**Recertification CARD Nos. 14/15**  
**Content of Compliance Certification Application and**  
**Compliance Recertification Application(s)**

**BACKGROUND (194.14 AND 194.15)**

**Figure 15-2. The WIPP Site is to the East of Nash Draw and Topographically Higher Than Nash Draw. Response to Precipitation Events at Surprise Springs Reflect Flow in Nash Draw, but not at the WIPP Site, Which is Over 8 Miles From the Land Withdrawal Boundary.**

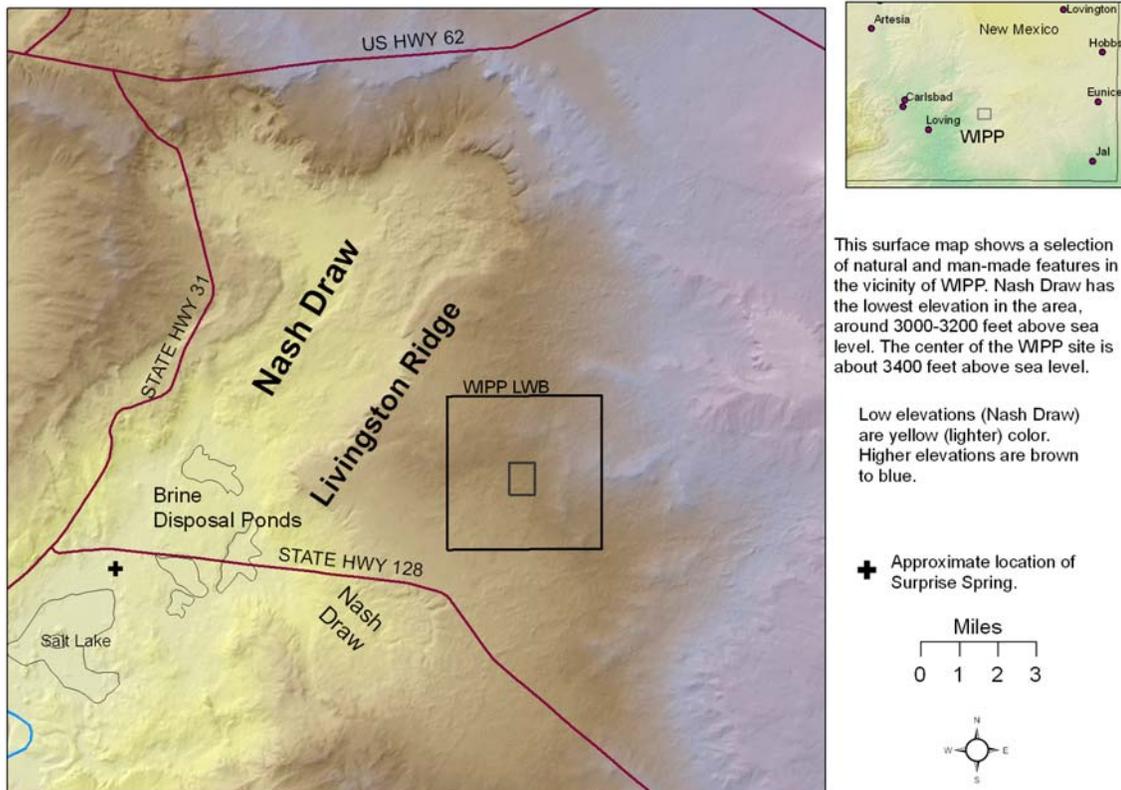
Because EPA's release requirements apply to the site, our primary interest is what happens at the WIPP site, that is, within the land withdrawal boundary (LWB), because the LWB defines the accessible environment. However, to get a better understanding of the WIPP site, it is useful to look at the area around the WIPP site. The land surface at the WIPP site generally slopes to the south and southwest. There is a topographic high, Livingston Ridge, northwest of the site, which is adjacent to Nash Draw, a topographic depression, further west (Figure 15-2).

Our understanding of the disposal system indicates that the WIPP site characteristics are distinct from Nash Draw such that extrapolations of karst in Nash Draw have little bearing on the WIPP site. Recharge characteristics and resulting discharge are one example of misrepresentation of the data by commenters. Precipitation events that occur in Nash Draw affect Nash Draw but appear to be independent of the WIPP site. The use of Surprise Spring in Nash Draw (see Figure 15-2) as an indicator of karst at WIPP is inappropriate. Surprise Spring is over 8 miles from the WIPP LWB. With the northeast to southwest flow in Nash Draw and a water table that is near the surface, Surprise Spring discharges are only a result of precipitation events that affect Nash Draw. In contrast at the WIPP site, well head data shows no response to precipitation events.

**Figure 15-4. Four Hydrochemical Facies in the Culebra Siegel et al. 1991**

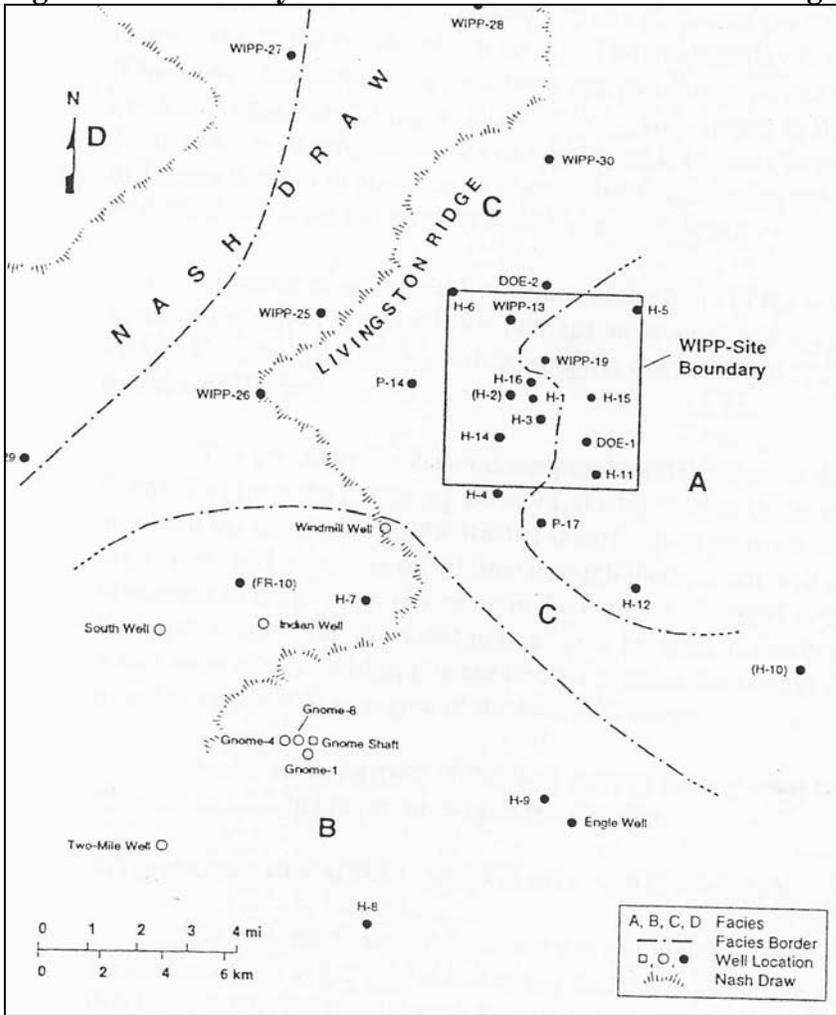
EPA believes that, on a regional scale, the groundwater basin model done by DOE reasonably predicts the current ground water flow regime and the geochemistry of the site.
